Subject: WATER AND WASTEWATER CAPACITY AVAILABILITY LETTER REQUEST

501 Art Lofts - DRC Case No. UDP-S24025 501 SW 2nd Avenue, Fort Lauderdale, FL 33301

Subject: WATER AND WASTEWATER CAPACITY AVAILABILITY LETTER

# City of Fort Lauderdale Public Works Department Water and Wastewater Capacity Analysis

Figure 3 - Required Improvements

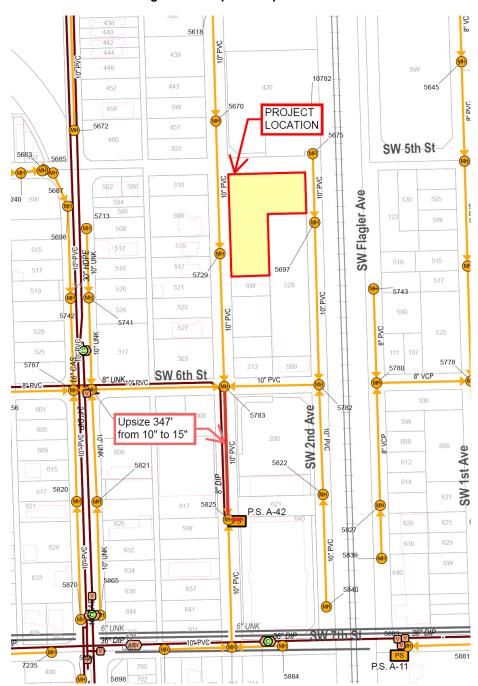
The proposed water infrastructure has the capacity to support the proposed development. The sewer infrastructure requires improvements to meet the increased demand of the proposed project, see Figure 3 Required Improvements. Master permit will not be issued for this site until the sanitary sewer system improvements are constructed, certified, and in service.

**Evaluation of impact on existing collection pipe:** According to the site plan, the applicant is proposing to utilize the 10-inch gravity sewer main to the east of the project site along SW 2<sup>nd</sup>Avenue. Accounting for existing flows and based on the tools and information available to the City staff, it has been calculated that the pipes downstream of the proposed development will flow higher than the City's governance plan threshold of 70% during peak flows. Therefore, the pipes downstream of the developments will have to be upsized to adequately serve the proposed project.

**Recommended Wastewater Infrastructure Improvements:** Approximately 347 LF of the existing 10" gravity sewer along SW 3<sup>rd</sup> Avenue will have to be upsized to 15 inches to adequately serve the proposed development (see Figure 3). Master permit will not be issued for this site until the sanitary sewer system improvements are constructed, certified, and in service.

Figure 5

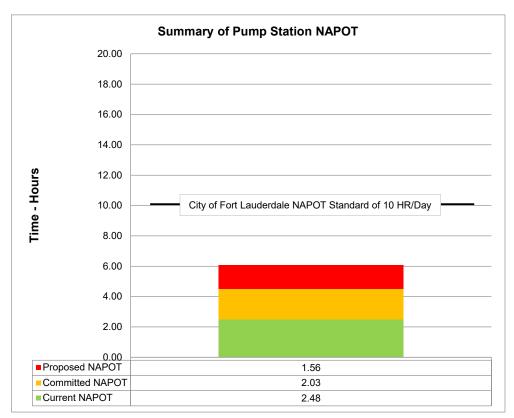
**Evaluation of impact on pumping station:** PS A-42 has a duty point of 422 gallons per minute (GPM) and has a Nominal Average Pumping Operating Time (NAPOT) of approximately 2.48 hours per day. Based on projected sewage flows, the pumping run times would increase approximately 93 minutes per day. Additionally, there are other committed flows from proposed developments within the PS A-42 basin resulting in 121.76 minutes of additional runtime. PS A-42 will have a NAPOT of 6.06 hours once the proposed developments are complete, less than the recommended average of 10 hours per day. See Figure 5 below.
